SUBJECT: AMENDMENT NO.128 TO FACILITY OPERATING LICENSE NO. DPR-43 -
 KEWAUNEE NUCLEAR POWER PLANT (TAC NO. M95302)

The amendment revises KNPP TS 4.2.b, "Steam Generator Tubes," its associated bases, and Figure TS 4.2-1 by redefining the pressure boundary for Westinghouse mechanical hybrid expansion joint (HEJ) steam generator (SG) tube sleeves.

SAFETY EVALUATION BY THE OFFICE OF NUCLEAR REACTOR REGULATION
RELATING TO AMENDMENT NO. 128 TO FACILITY OPERATING LICENSE NO. DPR-43

Application of Plugging Limit for a Westinghouse Mechanical Sleeve

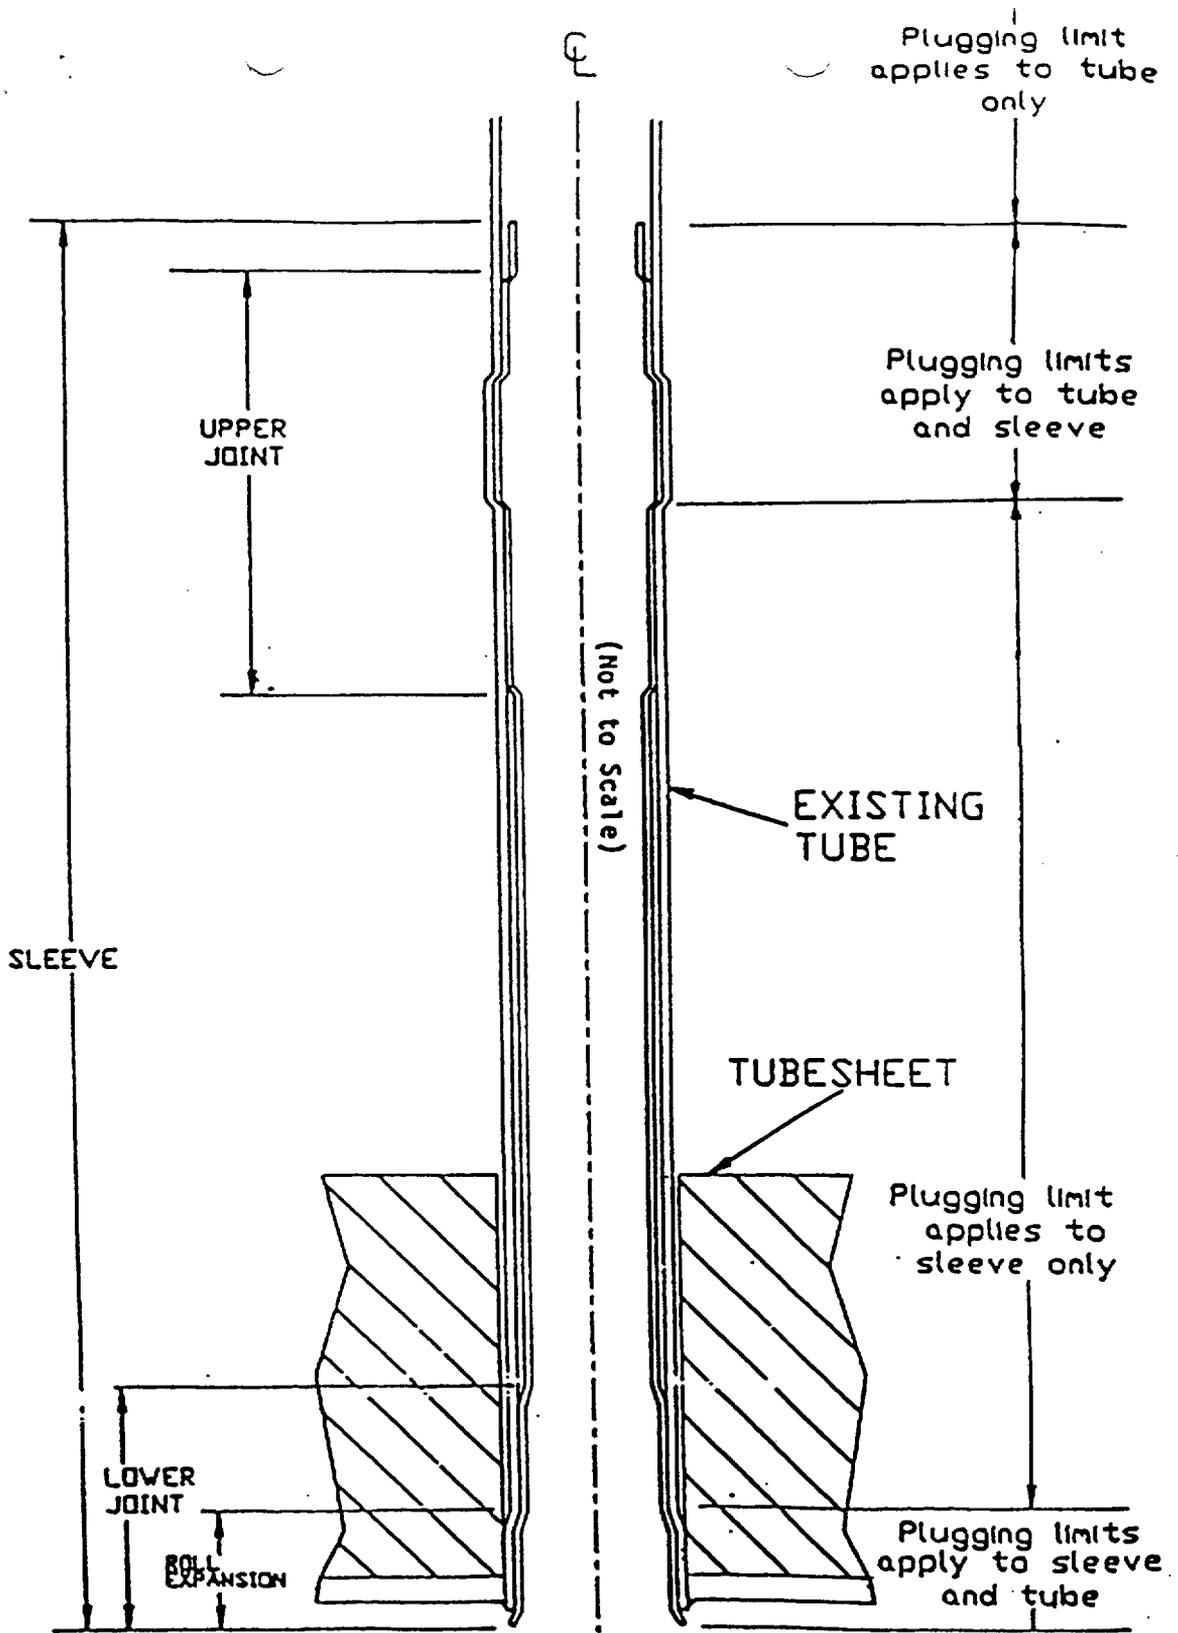
3. HEJ sleeved tubes with axial indications located within the parent tube pressure boundary as defined on Figure TS 4.2-1 shall be plugged or repaired prior to returning the steam generator to service.

4. HEJ sleeved tubes with parent tube indications located outside of the parent tube pressure boundary as defined on Figure TS 4.2-1 may remain in service.

For the Westinghouse mechanical sleeves, the sleeve plugging limit of 31% is applied to the sleeve as shown on Figure TS 4.2-1. For the Combustion Engineering leak tight sleeves, a plugging limit of 40% is applied to the sleeve and weld region. The sleeve plugging limits allow for eddy current testing inaccuracies and continued operational degradation per Draft Regulatory Guide 1.121 (August 1976).

The pressure boundary for HEJ sleeves is shown on Figure TS 4.2-1. The pressure boundary used to disposition parent tube indications (PTIs) detected in the upper joint of HEJ sleeved tubes is discussed in WCAP-14641⁽⁶⁾. The pressure boundary will allow PTIs located such that there is a minimum diameter change of 0.003 inch (plus an allowance for NDE uncertainty) between the peak diameter of the sleeve hardroll, and the diameter at the elevation of the PTI, to remain in service. The 0.003 inch interference lip is derived from structural and leakage testing. When inspecting and dispositioning the PTIs, the acceptance criteria will be adjusted to account for measurement uncertainties associated with the technique used to measure the relative change in ID sleeve diameters. During field application, the PTI elevation will be measured by comparing the diameter reported at the peak amplitude of the flaw, and the diameter at the center of the plus point coil's field, and using the more conservative of the two diameters to perform the ΔD determination. Application of the pressure boundary for HEJ sleeved tubes provides allowance for leakage in a faulted loop during a postulated steam line break (SLB) event. A SLB leakage of 0.025 gpm is assumed for each applicable indication. Steam line break leakage from all sources must be calculated to be < 34 gpm in the faulted loop. Maintenance of the 34 gpm limit ensures off-site doses will remain within a small fraction of the 10 CFR Part 100 guidelines for a SLB.

Figure TS 4.2-1 would be revised to reflect the revised boundaries for determining whether the plugging limit applies to the tube only, to the tube and sleeve, or to the sleeve only.

The staff has reviewed the TS changes discussed above and finds that they consistently incorporate the methodology for relocating the pressure boundary for HEJ sleeves as previously discussed in this safety evaluation and will provide adequate assurance of SG tube integrity. Therefore, the proposed changes are acceptable.
